Docket Item # 5
BAR CASE # 2009-0187

BAR Meeting
September 16, 2009

ISSUE: Alterations

APPLICANT: Washington Alexandria Architecture Center

Figure 7. Drawing of proposed alterations

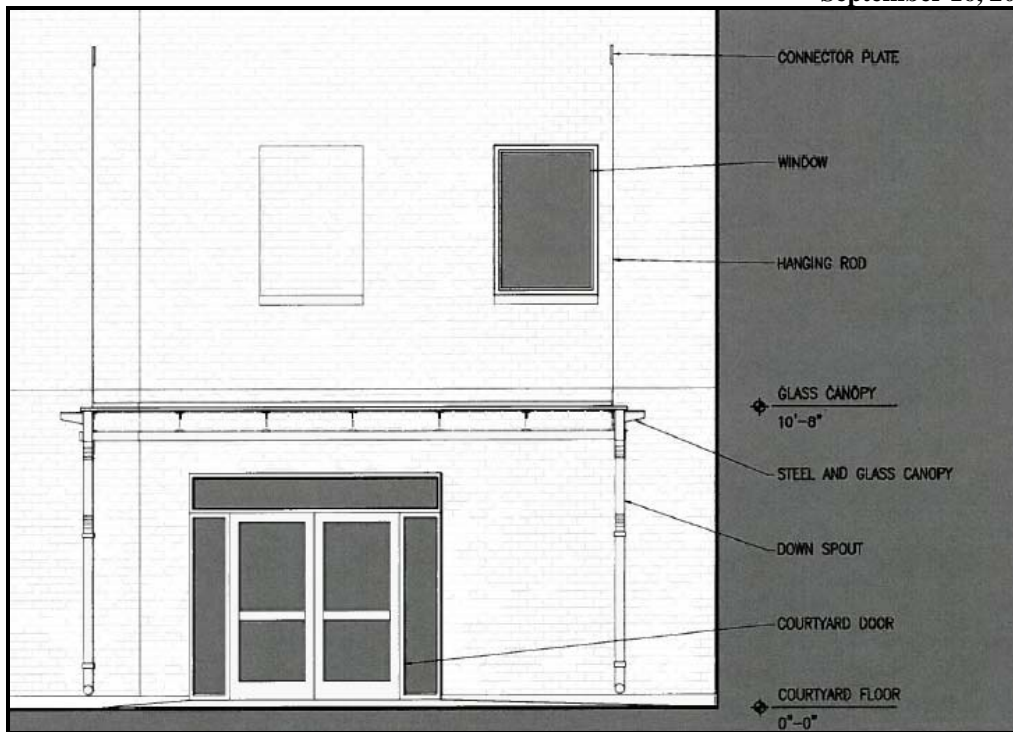
The applicant is requesting approval of a Certificate of Appropriateness for a glass and steel canopy to be located at the courtyard entrance of 1021 Prince Street. The proposed canopy will be mounted ten feet, eight inches above the courtyard floor and measure six feet, eight inches wide by 20 feet long. The proposed canopy is being relocated from an existing location and is therefore already constructed. The canopy is constructed of steel framing with a glass covering. It will be hung from the building by hanging rods and mounted into the masonry through connector plates. For the purpose of drainage off of the canopy the applicant is proposing the installation of two down spouts that will come down either side of the canopy and be mounted flush against the building. The proposed metal down spouts will be four inches in diameter and attached to the building with two inch wide metal wall straps.

- C-4 Canopies must comply with USBC 3202.3.1 for support and clearance from the sidewalk, and the applicable sections of USBC's Chapter 11. Structural designs of fabric covered canopies must comply with USBC 3105.3. The horizontal portions of the framework must not be less than 8 feet nor more than 12 feet above the sidewalk and the clearance between the covering or valance and the sidewalk must not be less than 7 feet.

- C-5 Canopies must comply with USBC 3105.1 and the applicable sections of USBC: Chapter 16. Structural designs of fabric covered canapés must comply with USBC 3105.3.

STAFF RECOMMENDATION: Staff recommends approval of the application as submitted.
